## REMARKS

Claims 1, 3, 7, 10-12, and 14 are pending. Claims 2, 4-6, 8-9, and 13 have been canceled. Claim 1 has been amended to incorporate the requirements of canceled original claims 2 and 4. Claims 7 and 12 have been amended into independent form. The other remaining claims have been amended to correct various formal matters without significantly changing their substance. No new matter has been added.

FIG. 1

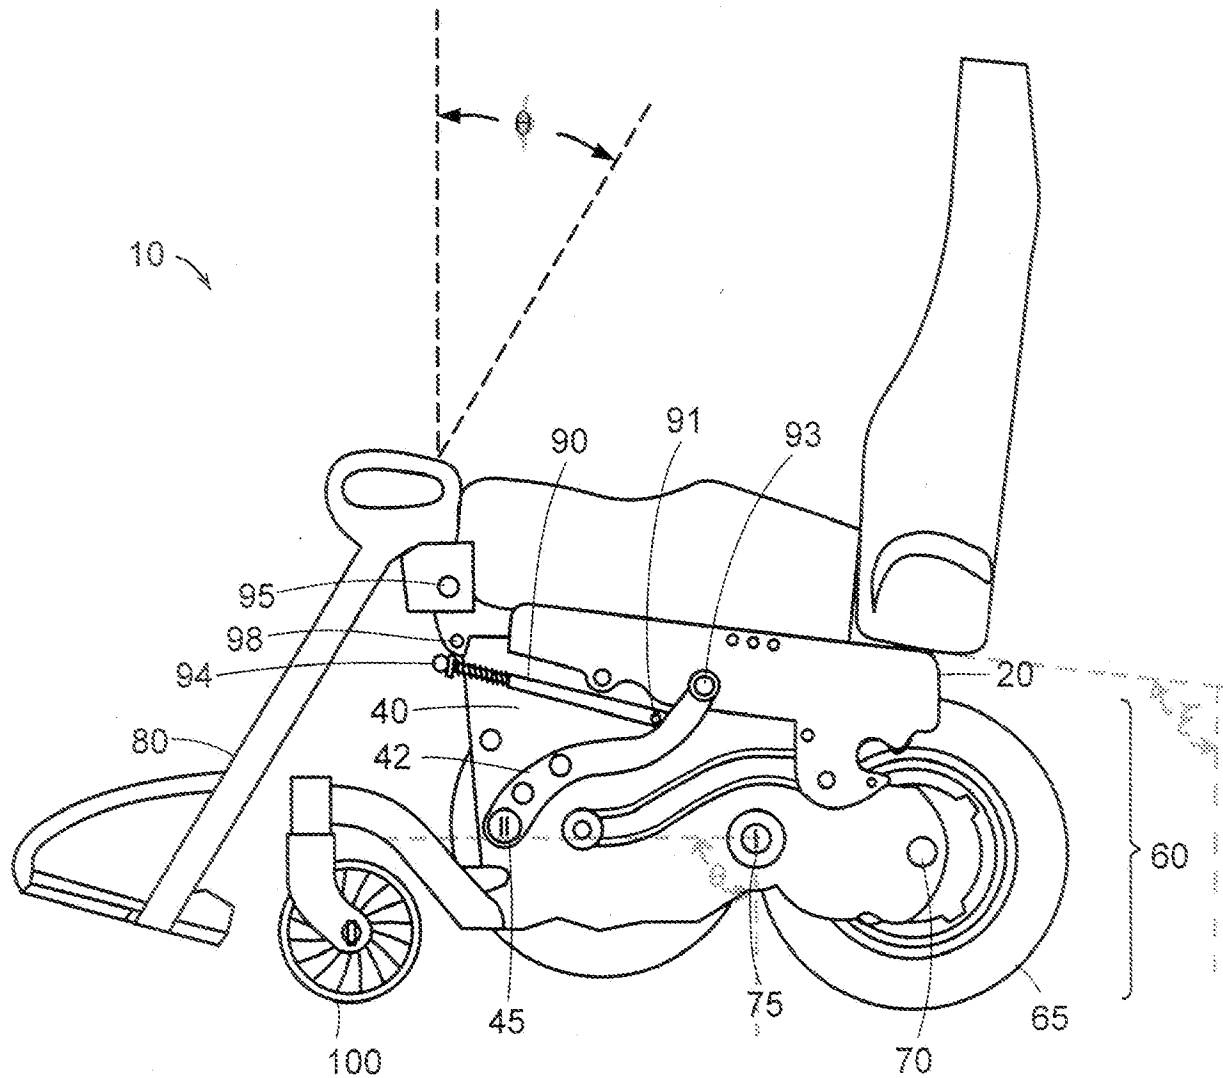
In paragraph 1 of the previous Office Action, the drawings were objected to as using reference characters 91, 93, 94 and 95 to all refer to a pivot point. This has been corrected by amending the specification to refer to element 91 as a "limit arm linkage pivot point" as described in the original application at page 4, line 31; to refer to element 93 as a "lifting arm support pivot point" as described in the original application at page 4, lines 30-31; to refer to element 94 as a "rest linkage pivot point" as described in the original application at page 4, lines 29-30; and to refer to element 95 as a "rest support pivot point" as described in the original application at page 4, lines 23-24. No new matter has been added.

In paragraph 2 of the previous Office Action, the drawings were also objected as failing to show various features of the claims. A new substitute Fig. 1 is submitted with this application showing the base pivot angle  $\theta$  and support pivot angle  $\zeta$ . The support pivot axis was already shown as element 45 and the surface contacting module was already shown as element 60. Claims referring to other elements missing from the drawings have been canceled.

With respect to paragraph 3 of the previous Office Action, the objection to the Specification referenced at page 4, line 23 has been corrected by amendment to paragraph [0016]. Similarly, the objection to the Specification referenced at page 5, lines 9, 12 and 19, and

page 6, lines 7 and 10 has been corrected by amending Fig. 1 to show the rest pivot angle with the symbol  $\varphi$  rather than as  $\theta$ .
